**VILLAGE OF GERMANTOWN**  
N112 W17001 MEQUON ROAD  
GERMANTOWN, WI 53022

| MEETING:       | <b>PLAN COMMISSION</b>                    |

# REZONING, CONDITIONAL USE PERMIT APPLICATIONS & SITE PLAN REVIEW

**To :** Jeffrey W. Retzlaff, AICP, Planning Director/Zoning Administrator  
**From :** John Laning, P.E., Village Engineer  
**Date :** October 13, 2017  
**Re :** Discount Ramps –Site Plan Review

## **C-2 General Notes**

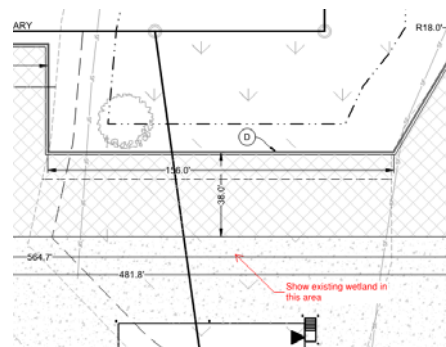
1. Site and Dimensional Plan Notes include references to the Village or Pleasant Prairie. Review notes and revise all municipal references to the Village of Germantown.

## C-5 Grading Plan

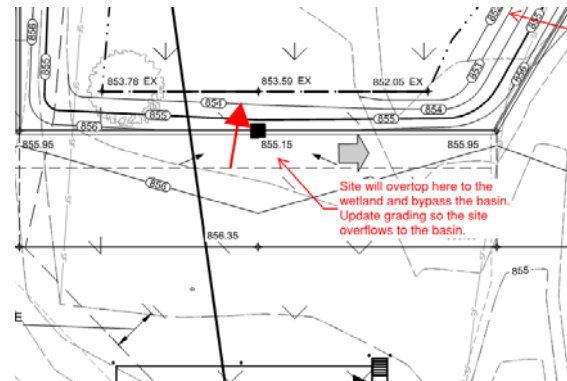
1. Based on proposed grades, overland flow will overtop the curb to the north and bypass the existing stormwater basin instead of overtopping to the east as indicated by the arrow. Adjust grading to have overflow routed to the existing stormwater basin and match the intended overflow arrow.

2. Show and label wetland setbacks as well as wetland buffer disturbance areas.
3. Add additional grade information to the loading dock area to clarify grades. Show grades at the bump out in the center of the building and at the bottom of the stairs.
4. Install new permanent ditch checks in the swale on the west side of the site to replace the existing ones.
5. Bypass swale on the west side of the site is being made narrower and shallower. Provide calcs showing that it can still safely pass the tributary flow from the 100 year storm event without overtopping.
6. It appears the top of curb will be higher than the door elevation on the west side of the building. Add spot grade information to clarify how this will work.

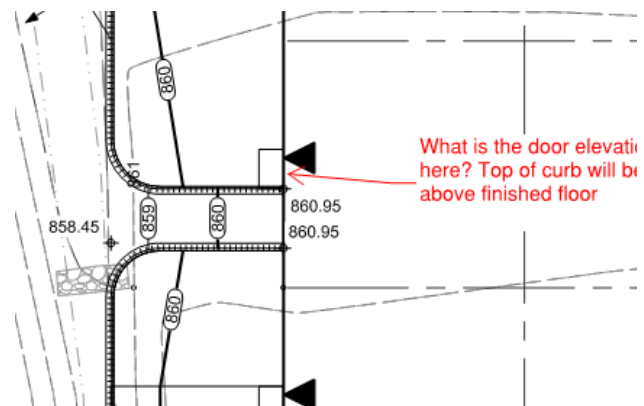
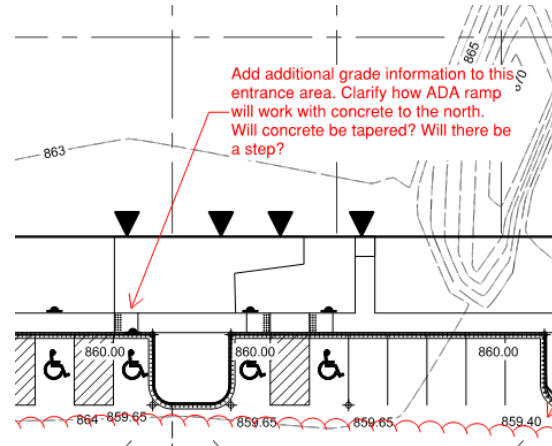
7. Add additional spot grade information to the main entrance area. Clarify how curb ramp will work with concrete to the north. Will there be a step here?

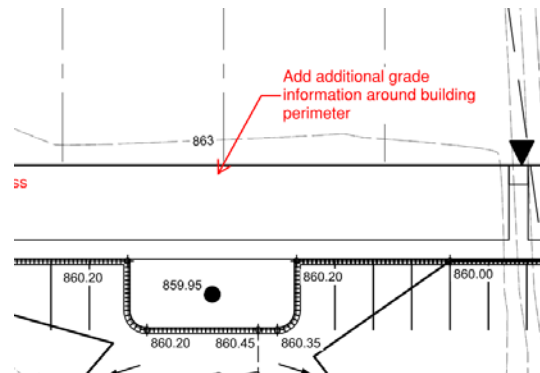
8. Add ground grades and sidewalk grades around the entire building perimeter. Based on curb grades shown it appears some areas between the sidewalk and building will be very flat or need to have the ground grade higher than the finished floor. (example at south of building in image)

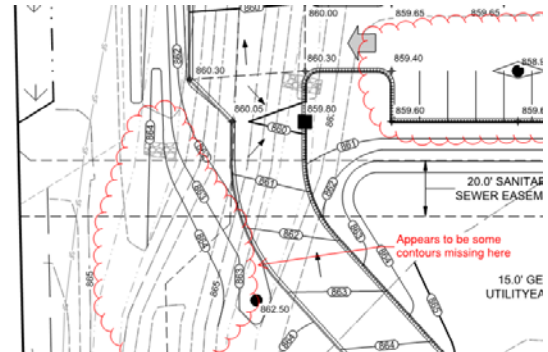
9. It appears some contours are missing in this area on the southwest side of the site.

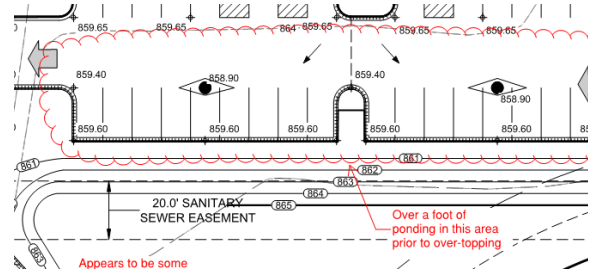
10. Grading plan will create over a foot of ponding prior to overtopping for the area south of the ADA parking. Revise grading plan to allow for a maximum of 6" of ponding in parking areas.

### **C-9 Construction Details**

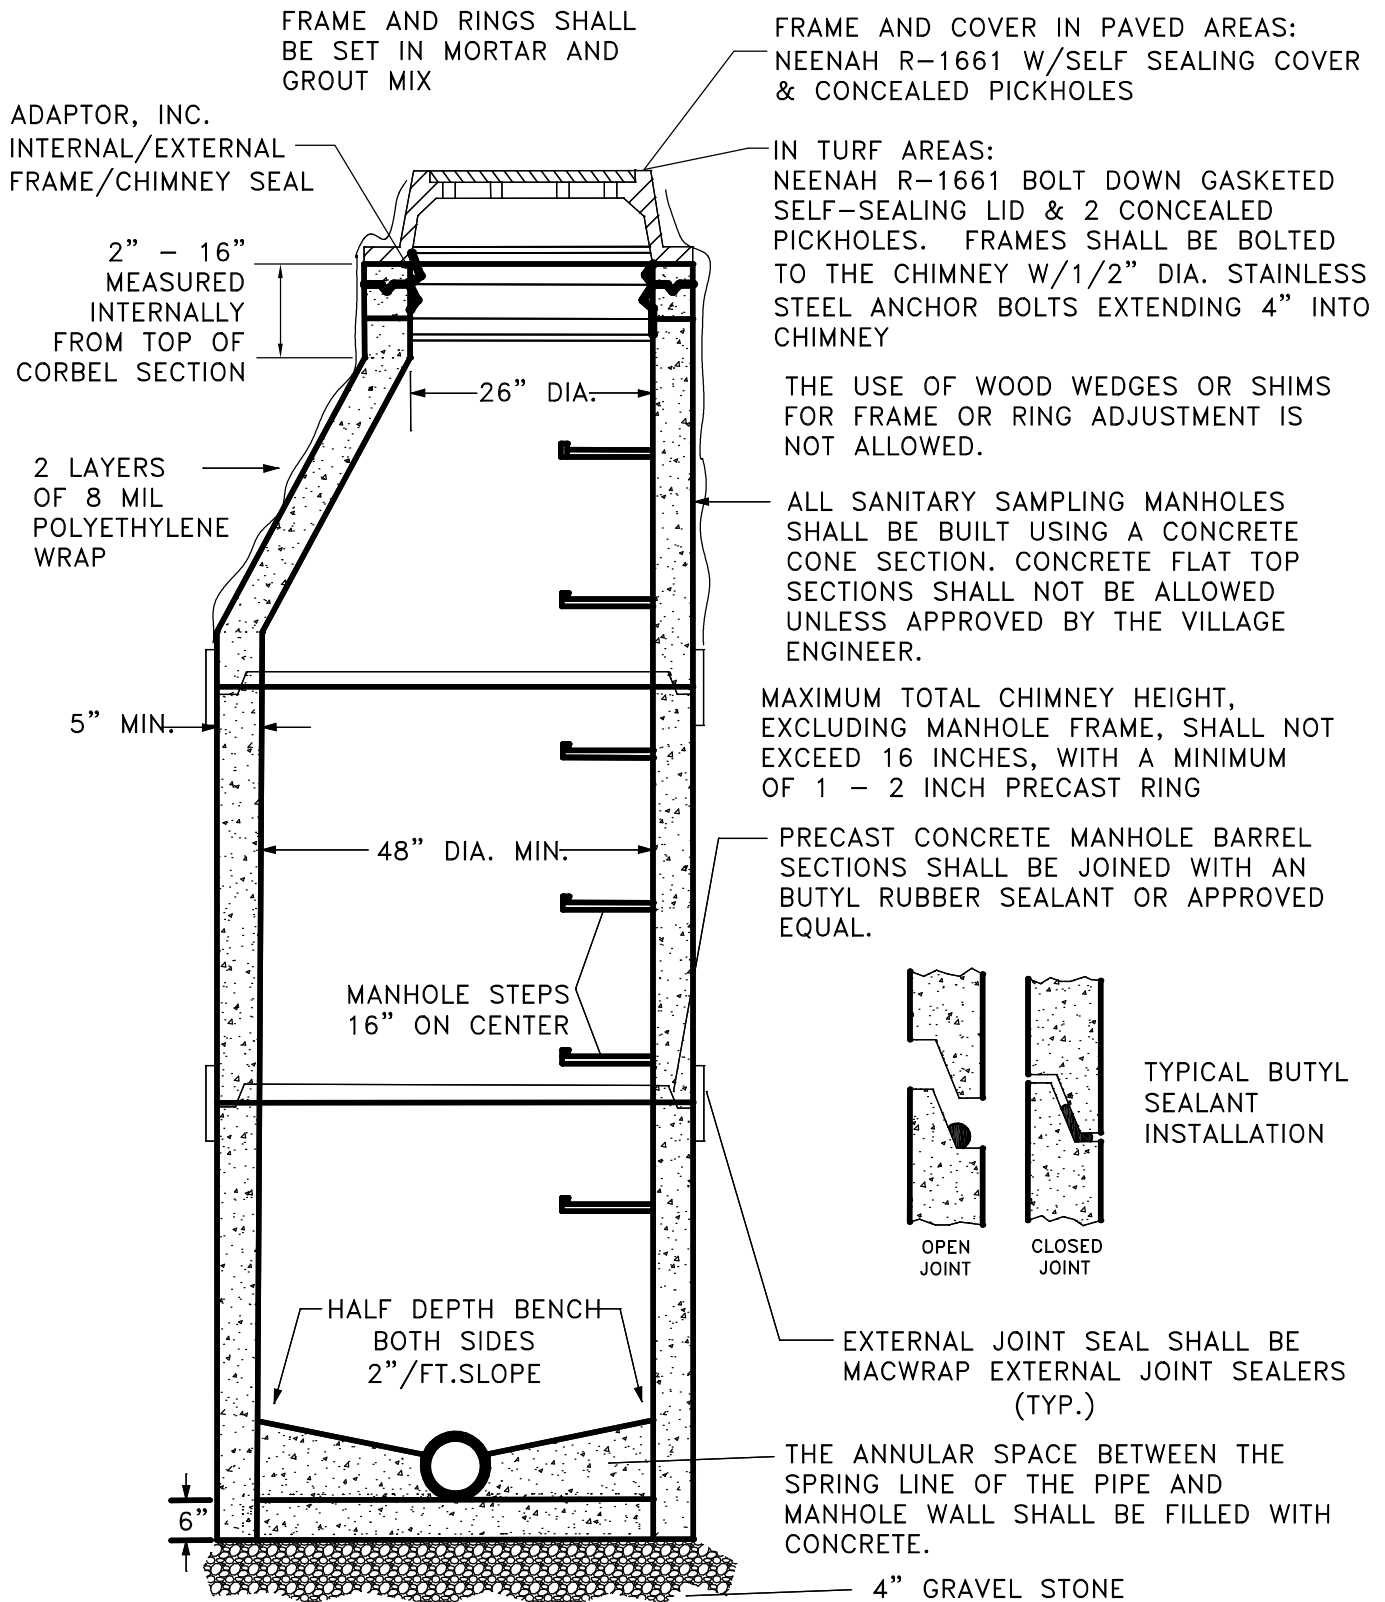
1. Replace the hydrant detail with the Village's standard hydrant detail (attached).
2. Replace the sampling manhole detail with the Village's standard sampling manhole detail (attached). Manhole is to be epoxy coated inside and out per detail.
3. Watermain depression notes call for 16" seperation. Revise to 18" minimum.
4. Watermain depression detail references IEPA. Change to WDNR.
5. Fire Connection detail – Where is this located? Show location on Utility plan.
6. Flared end section grate detail has reference to IDOT. Revise to WisDOT

## EXISTING CONDITIONS

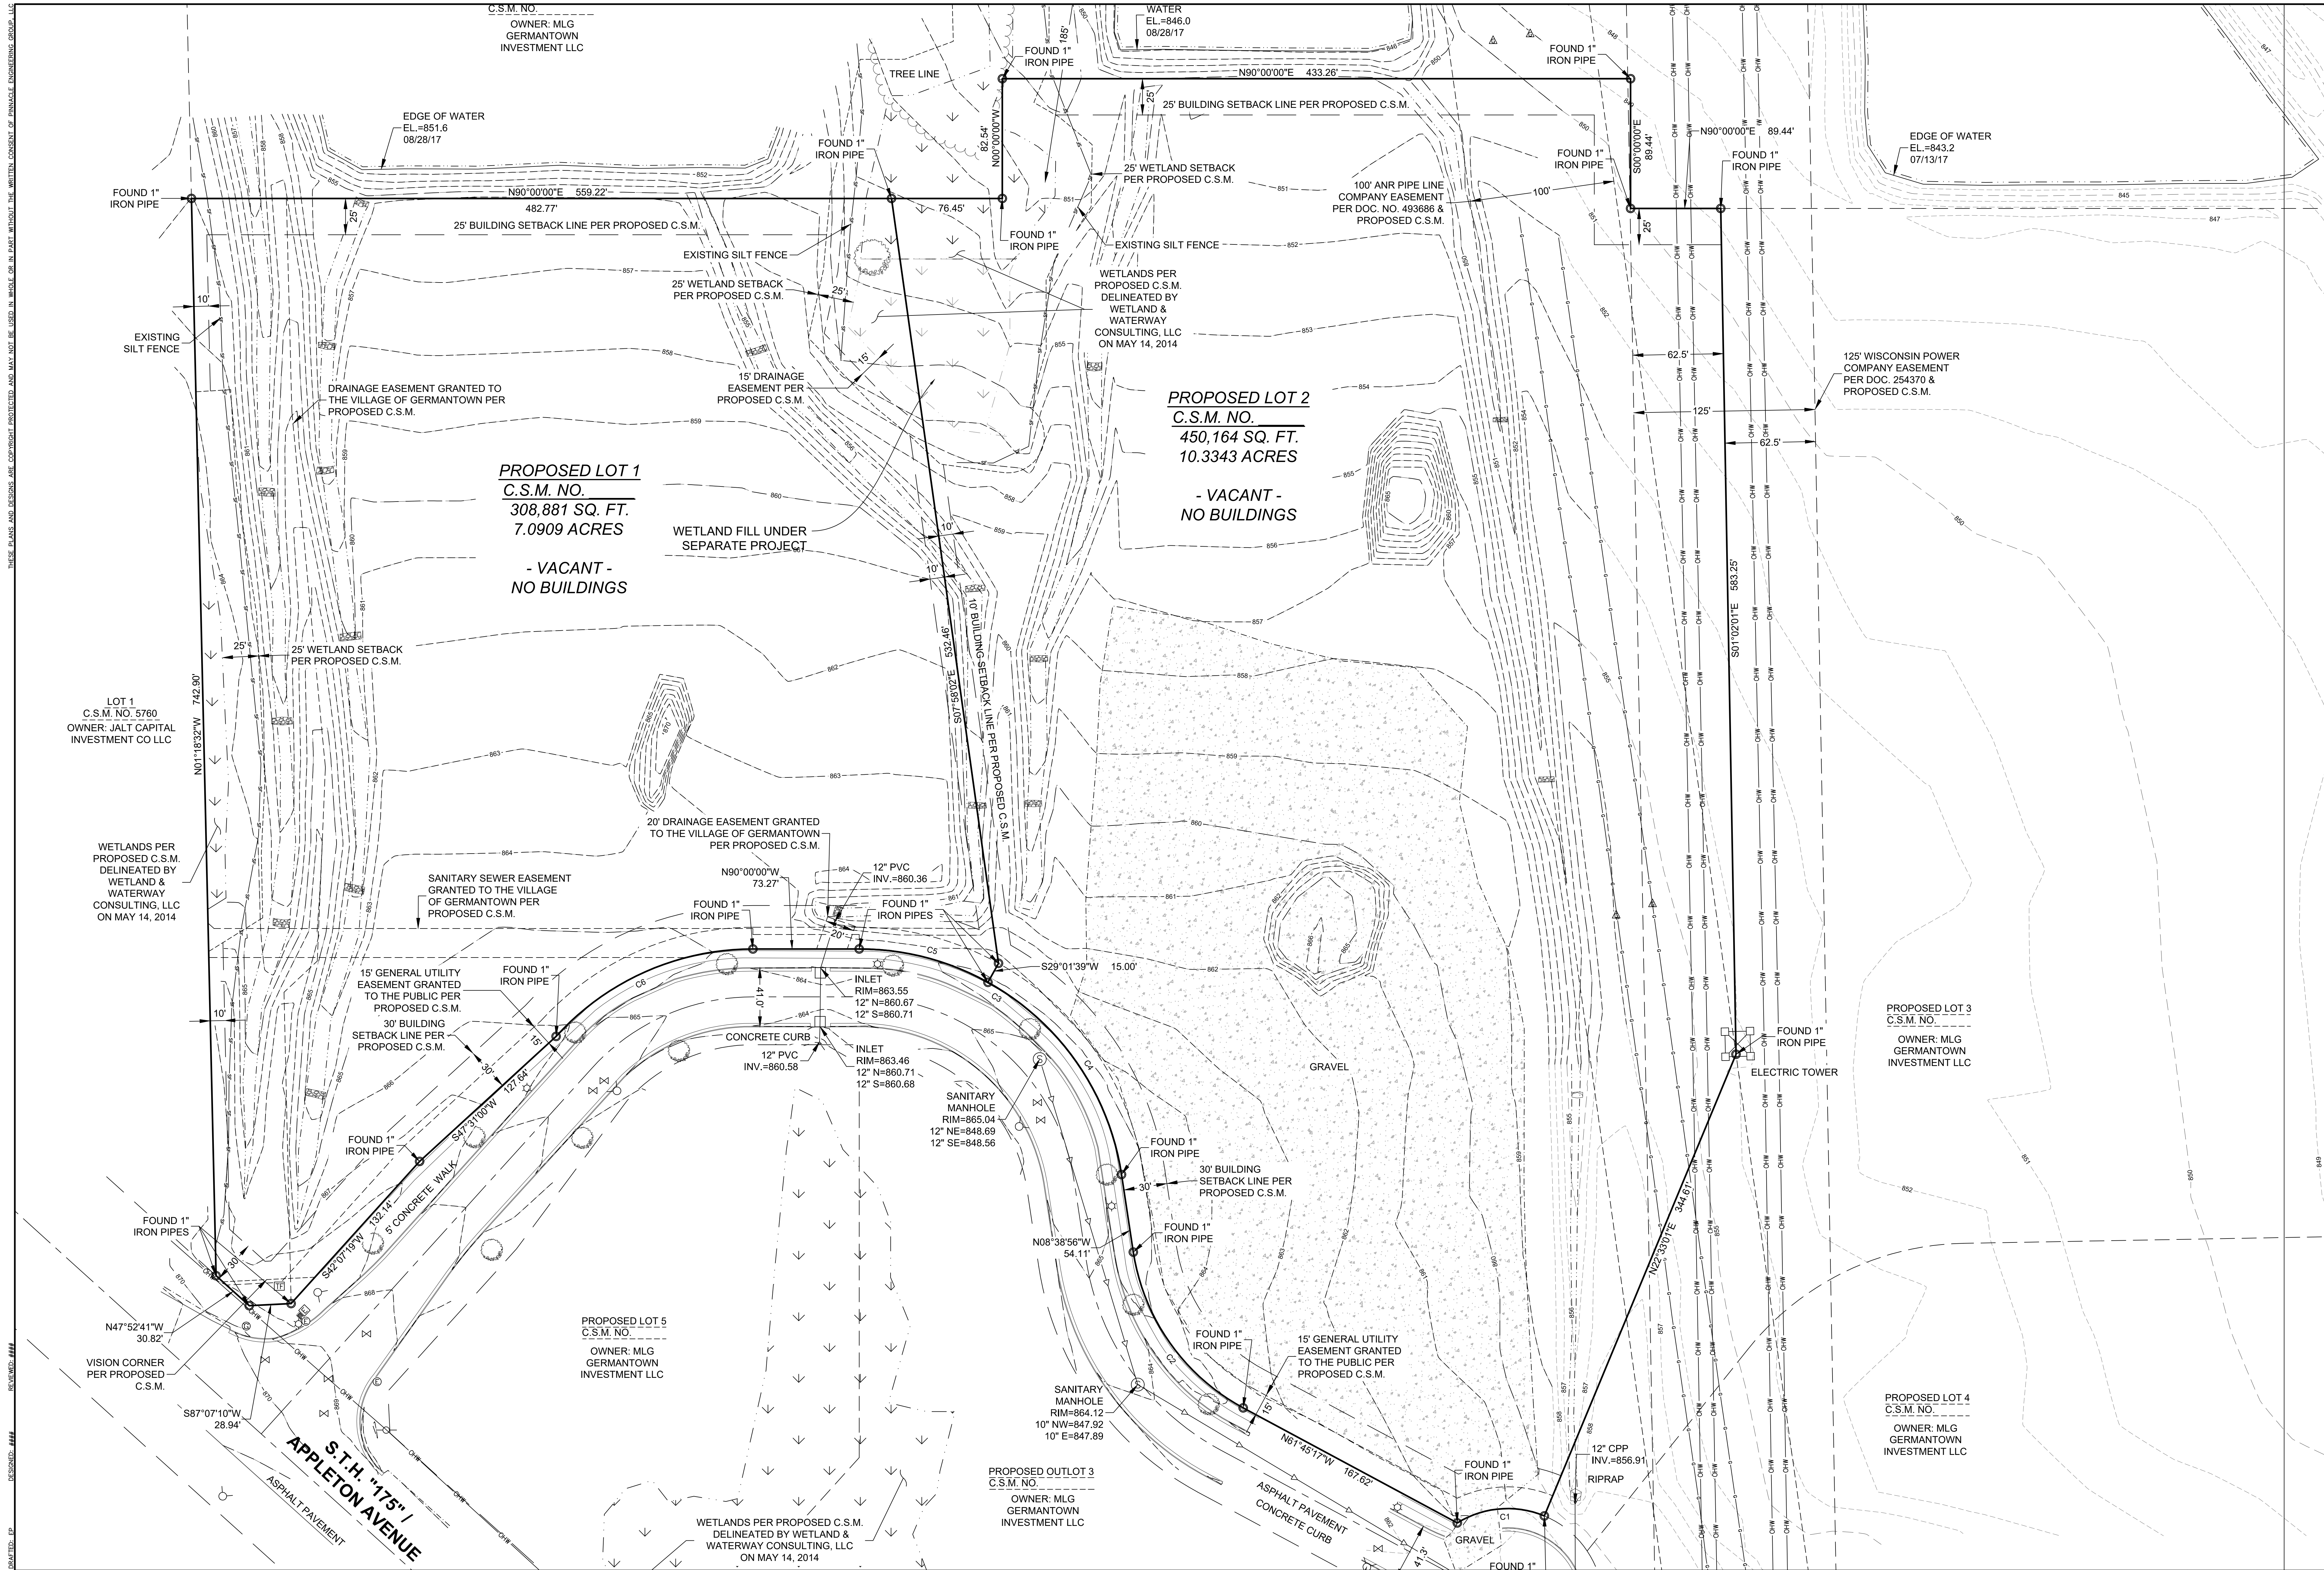
1. Add street names for all roadways.
2. Add existing utility information to the plan. Sanitary, watermain, and dry utilities (gas, electric, phone, fiber, etc), show all existing public and private utilities.
3. There is a 200' no blast zone adjacent to the gas pipeline on the east side of the site. Add this 200' line to the plans and show on all sheets. Any work within the 200' zone needs to be approved by TransCanada Engineering.
